FMVSS Noncompliance Recall

N162016079 Park/Position Lamp Intensity

Release Date: October 2021

Revision: 01

4626097

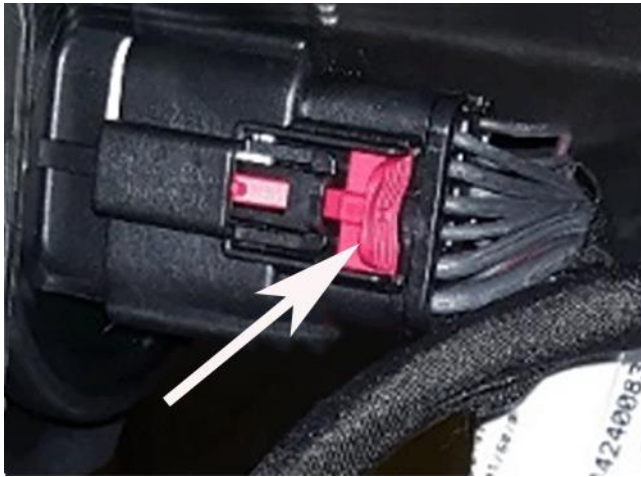
4. Install the jumper harness to the lamp harness and plug the jumper into the left headlamp.

4627038

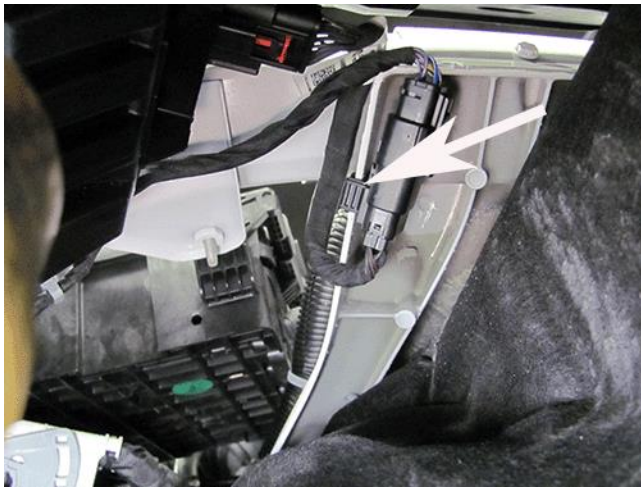
5. After the jumper harness is installed, engage the CPA clip (the red locking tab on the connector).
